To: North Yorkshire Council, Planning Department

From: Foxholes & Butterwick Parish Council

Subject: Planning Application: **NY/2025/0113/FUL**

Please see image below (courtesy of public source information - MagicMap)

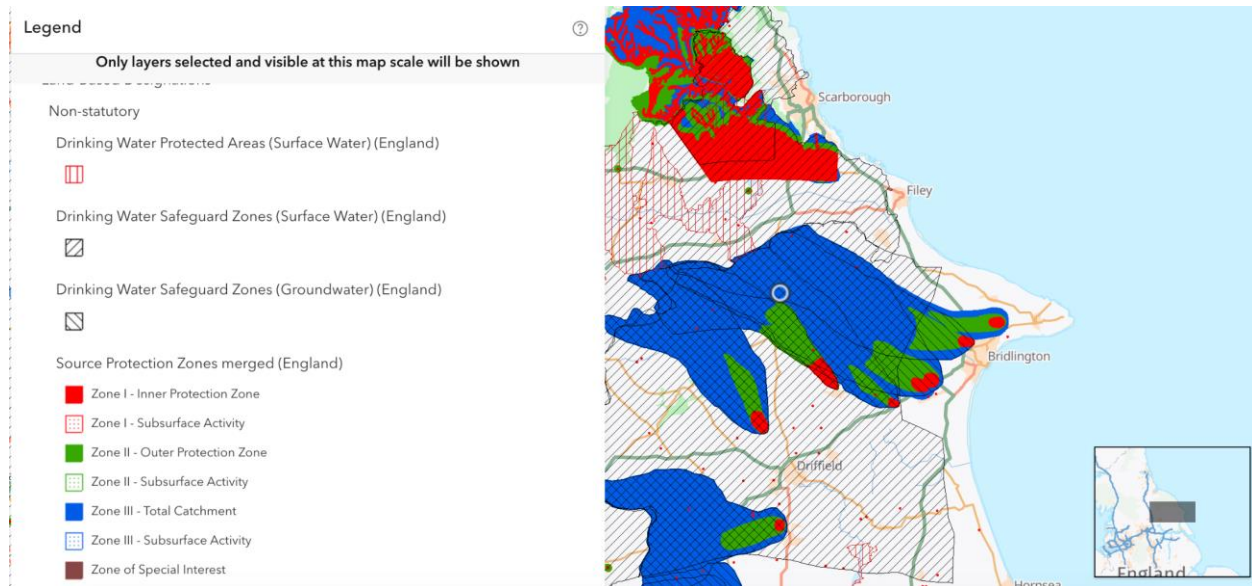
The proposed drilling site, specifically, sits within a field designated as a Source Protection Zone (SPZ) type 3. Meaning Foxholes sits in what is termed a Total Catchment Zone. This defines an area from which groundwater flows towards an abstraction point (well or spring). One of which locally is Haisthorpe, near Bridlington. Here, the borehole supplies local water, which is treated at Yorkshire Water's Haisthorpe Treatment Works. Essentially, Foxholes sits within a SPZ3, where any pollution or changes to the groundwater could affect the water being drawn for drinking or other uses.
